# Proposal for Mated Test Fixture Performance

Sam Kocsis, Amphenol

*Related to comments #459, #460, #461, #462, #463, #464, and #465*

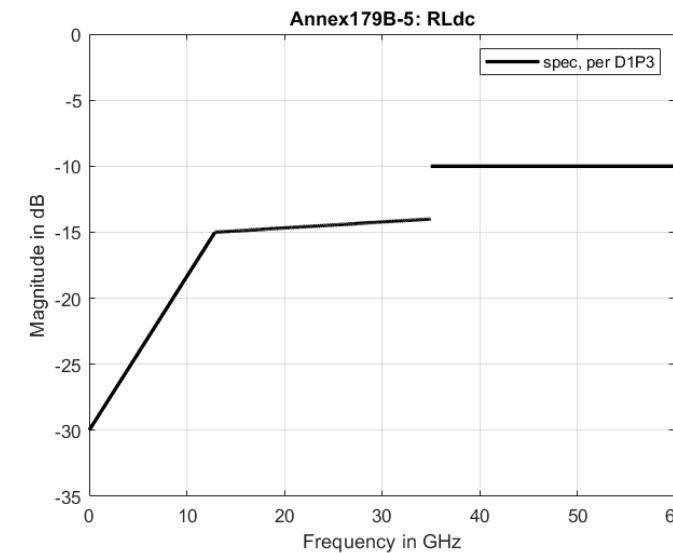
# Comment #464 (and #529)

- Fix the broken equation

$$RLdc(f) \geq \begin{cases} 30 - 15 \frac{f}{12.89} & 0.01 \leq f < 12.89 \\ 15 - 5 \frac{f - 12.89}{35 - 12.89} & 12.89 \leq f < 35 \\ 10 & 35 \leq f \leq 60 \end{cases} \quad (179B-8)$$

$$RLdc(f) \geq \begin{cases} 30 - 15 \frac{f}{12.89} & 0.01 \leq f < 12.89 \\ 15 - 5 \frac{f - 12.89}{35 - 12.89} & 12.89 \leq f < 35 \\ 10 & 35 \leq f \leq 60 \end{cases}$$

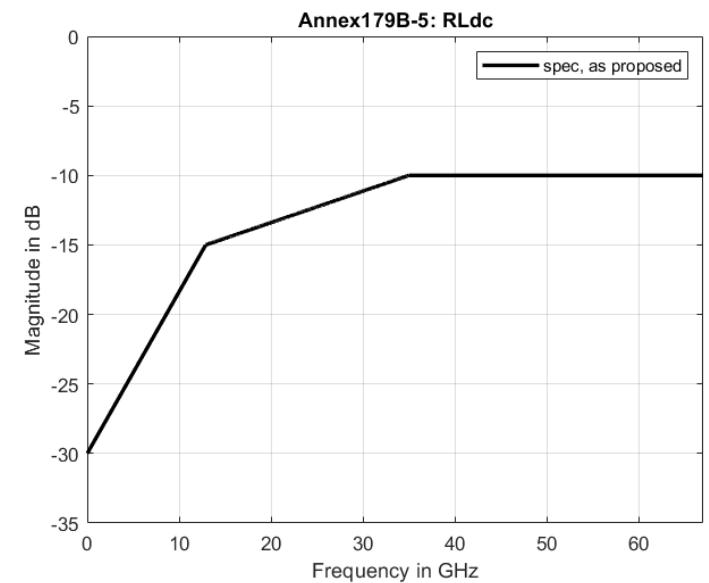
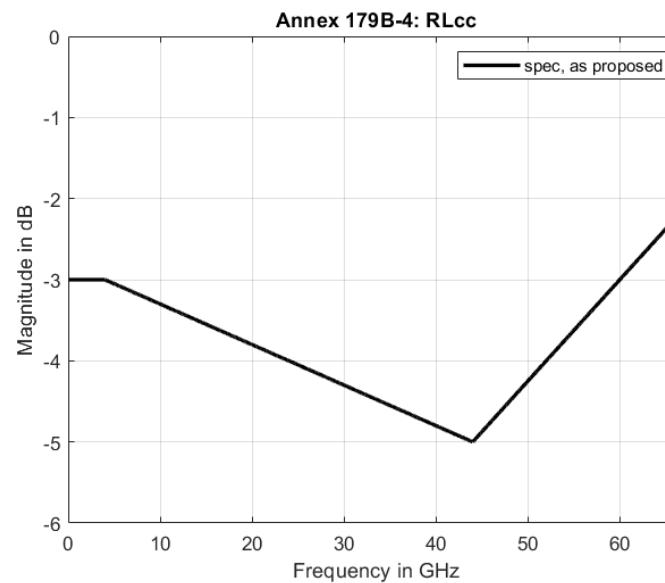
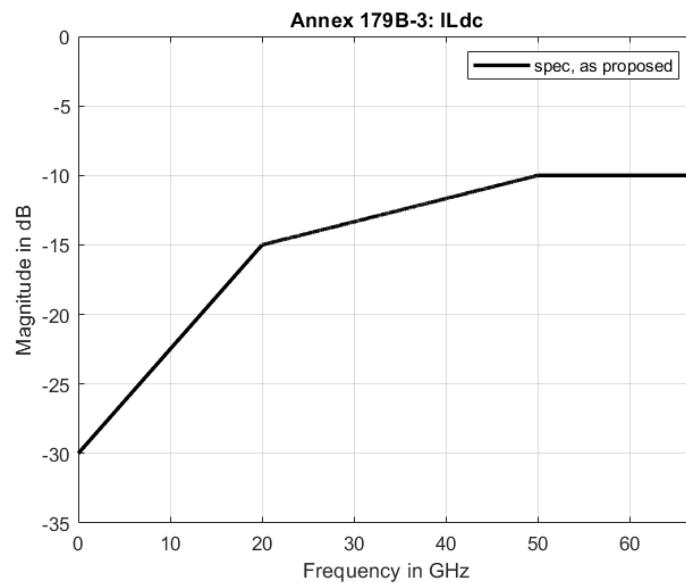
# Comment #464 (and #529)

- With other parameters in Annex179B requiring 67GHz bandwidth, extended equations 179B-6,7,8 to 67GHz is reasonable

$$ILdc(f) \geq \begin{cases} 30 - 15\frac{f}{20} & 0.01 \leq f < 20 \\ 15 - 5\frac{f-20}{30} & 20 \leq f < 50 \\ 10 & 50 \leq f \leq 67 \end{cases}$$

$$RLcc(f) \geq \begin{cases} 3 & 0.05 \leq f < 4 \\ 3 + \frac{2}{40}(f-4) & 4 \leq f < 44 \\ 5 + \frac{2}{16}(44-f) & 44 \leq f \leq 67 \end{cases}$$

$$RLdc(f) \geq \begin{cases} 30 - 15\frac{f}{12.89} & 0.01 \leq f < 12.89 \\ 15 - 5\frac{f-12.89}{35-12.89} & 12.89 \leq f < 35 \\ 10 & 35 \leq f \leq 67 \end{cases}$$
